7 WTC

FUEL OIL TANK FOR MAYOR"S OFFICE

To: Mr. Lou Menno, General Manager, World Trade Tenant Services
From: C. John Lin, P.E.
Date: March 9, 1998
Subject: **WTC - ALTERATION APPLICATION W-987134 - MAYOR'S OFFICE - 7 WTC, 1ST FLOOR - MAYOR'S EMERGENCY MANAGEMENT OFFICE**

ALTERATION APPLICATION W-987134

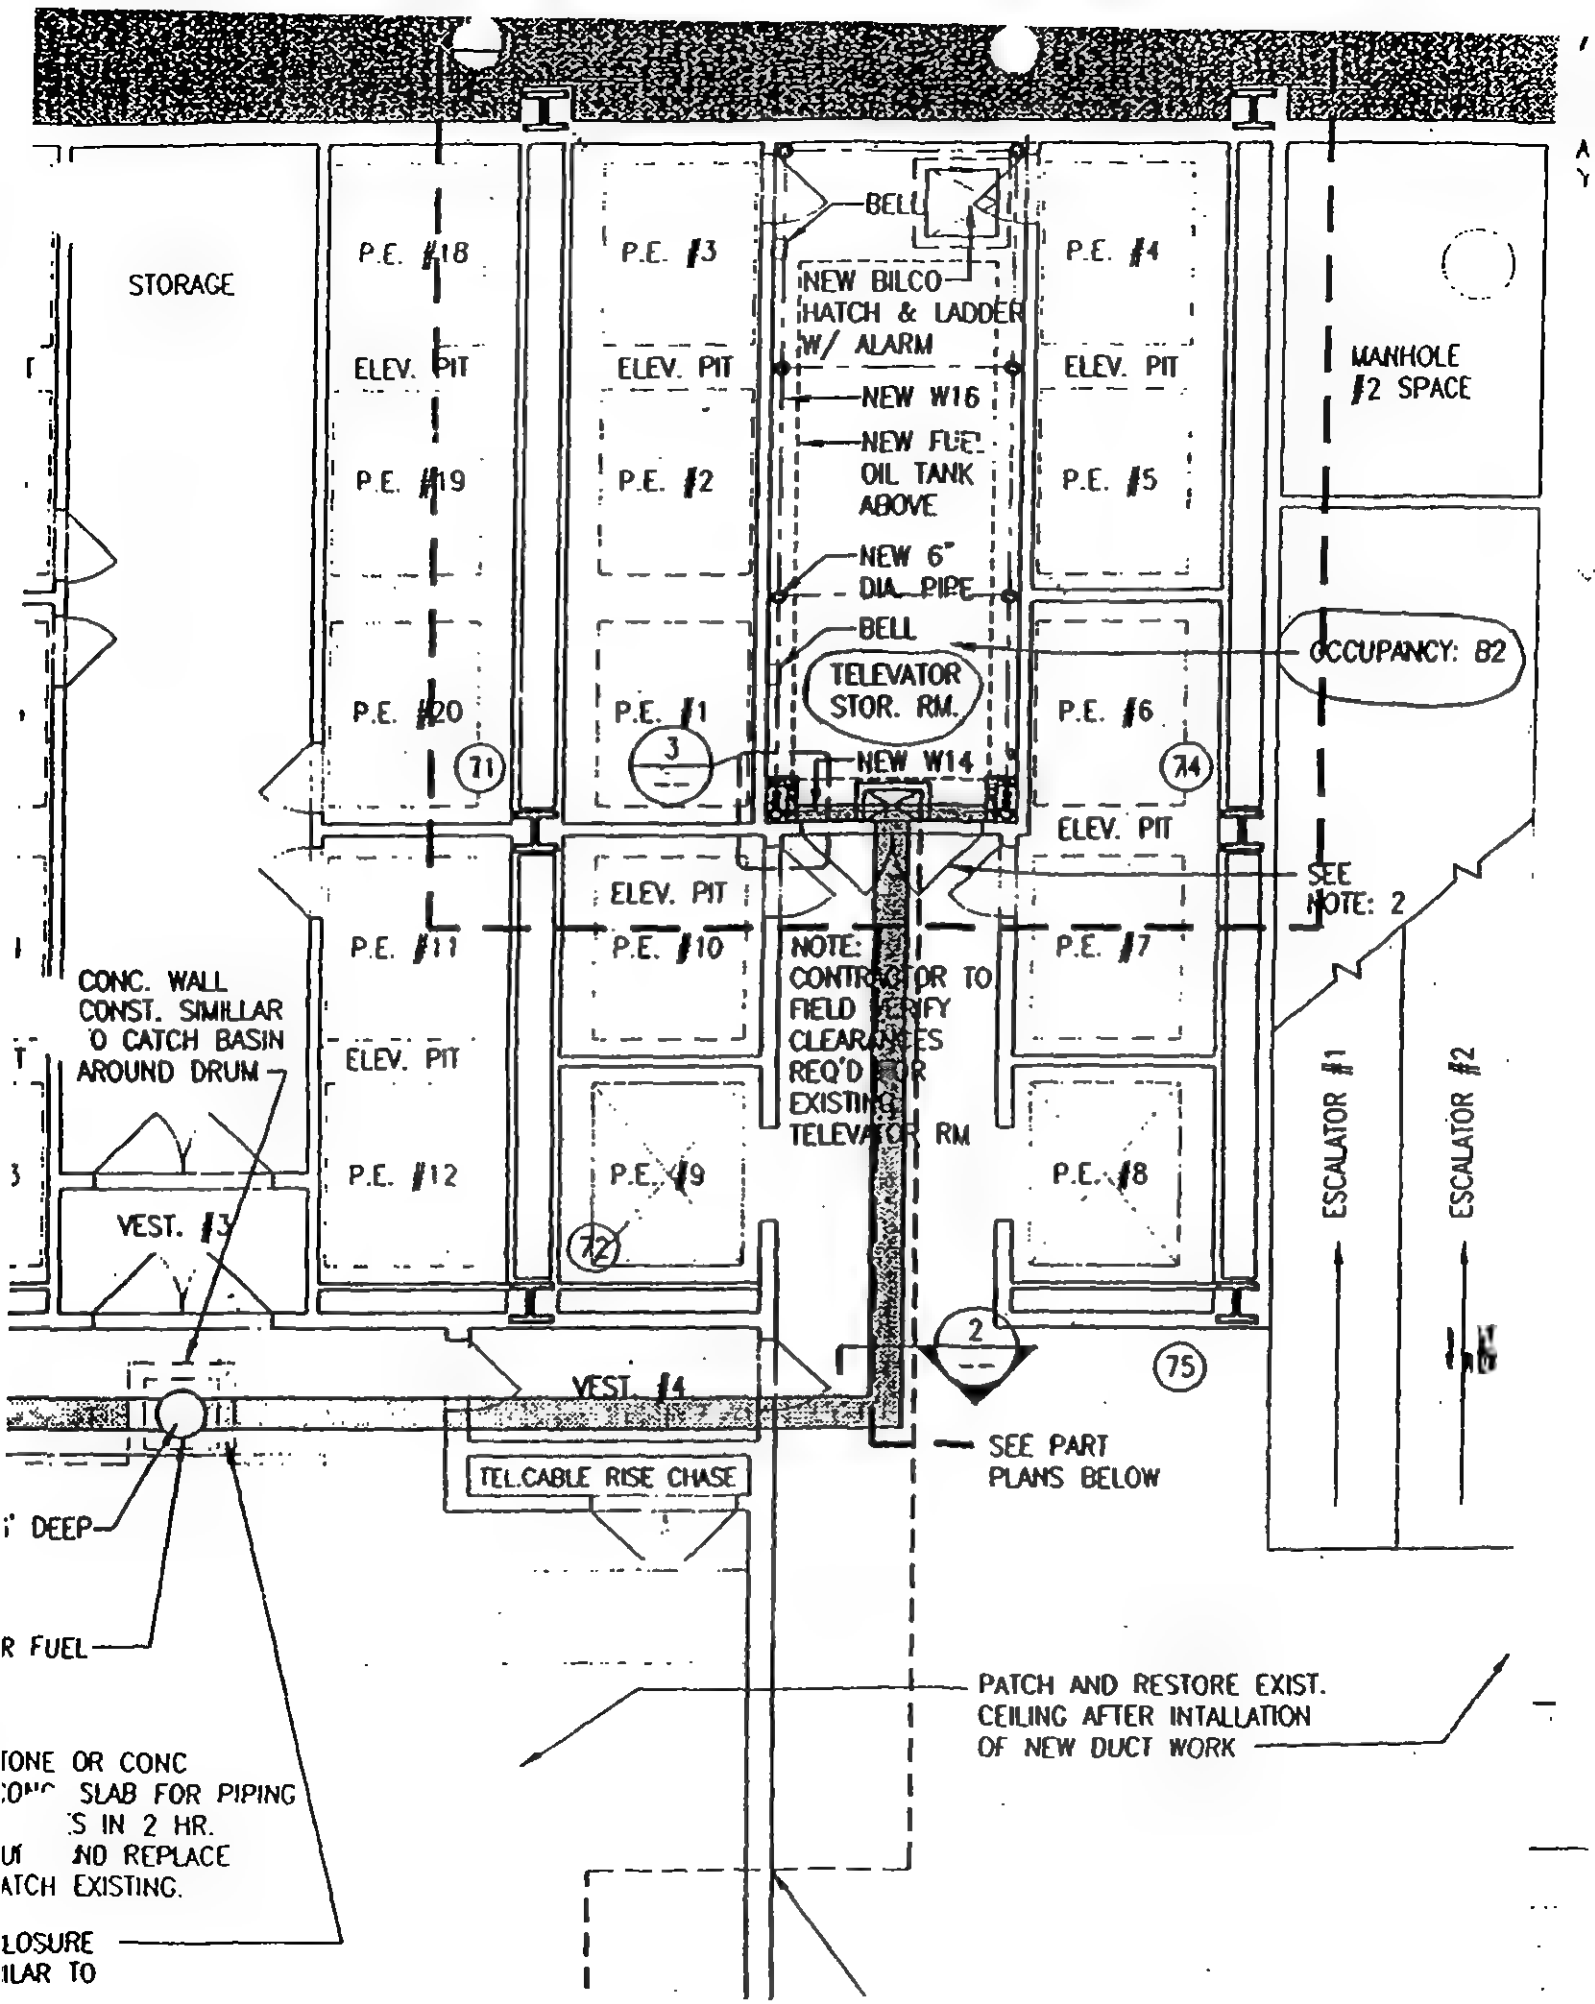
2. Drawing A-1-1. Please investigate the existing structure for its adequacy to support the load of the new fuel oil storage tank.

4. Drawing A-1-1. The space shall be ventilated as required by Code Section 27-405, high hazard occupancy.

5. Drawing A-1-1. Provide extra hazard sprinkler protection for the tank room, as the space is classified "high hazard," see Comment 1 above.

* 3. Drawing A-1-1:

a) Provide an approved assembly numbers for the four hour rating for concrete floor, 8" concrete block wall and fireproofing over deck and beams. See NYC Building code Section 27-322.

b) Provide a rated hatch at the elevated slab to maintain the integrity of the rated construction, as per NYC Building Code Section 27-342.

c) Revise the note at Part Plan - Mezzanine "New full height CHU (4HRS)" instead of 3 HRS as stated on the Drawing.

7 SECTION THROUGH FUEL OIL TANK ROOM

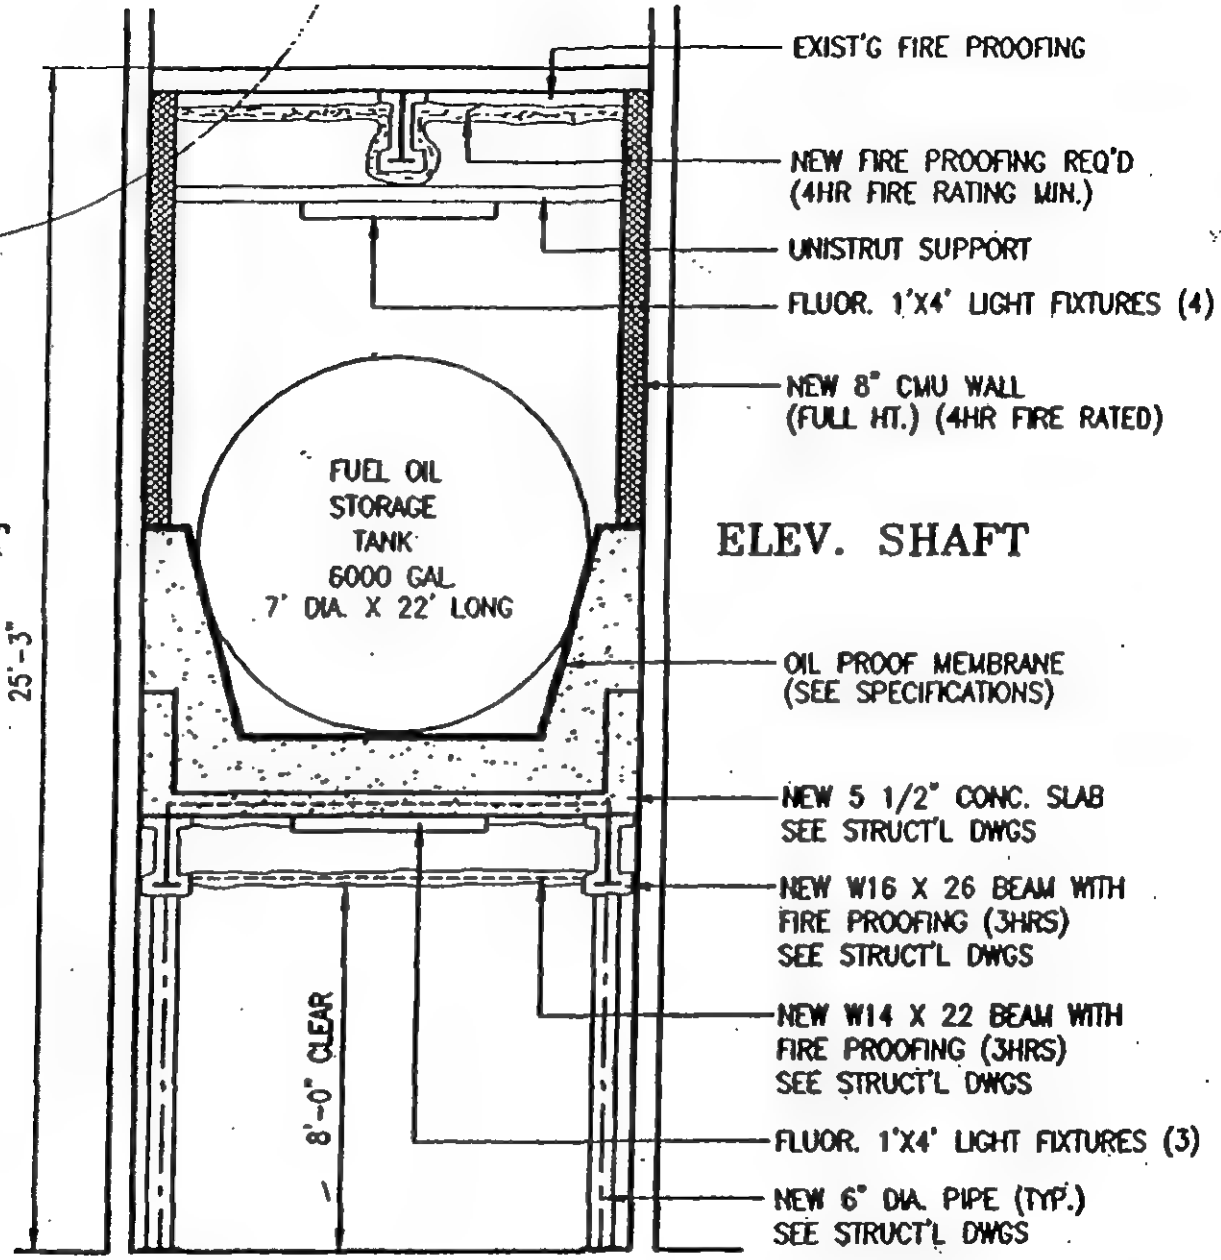
11. Draving A-1-1, Section 7. The space under the fuel oil storage tank may be used for charging storage batteries on an electric vehicle. Show explosion-proof wiring methods, to guard against the accumulation of an explosive mixture of battery gases. The storage batteries can produce explosive gases, even if sealed recombination-type batteries are used. See NYC Electrical Code Section 27-3158, the 11/18/92 minutes of the NYC Electrical Code Revision and Interpretation Committee, NEC Section 480-8(a), and PA Tenant Construction Reviev Manual Section 10-V.D.7.

18. Draving A-1-1; Detail 7, Section through Fuel Oil Tank Room. As required by the NYC Building Code Section 27-829(a)(3), the clearance between the rated non-combustible enclosure and all the sides of the storage tank shall be at least 15 inches. In addition, clarify whether the 2 foot high concrete curb (Detail 6, Part Plan Mezzanine) together with the "oil proof membrane" portion of the enclosure will hold at least equal the capacity of the 6000 gallons storage tank.

REMARKS: 1) Please inform the tenant in writing that Swanke Hayden Connell Architects, in their 5/13/98 response to previous Electrical Comment 11, referring to Drawing A-1-1, Section 7, advises not to use the space under the fuel storage tank for charging storage batteries.
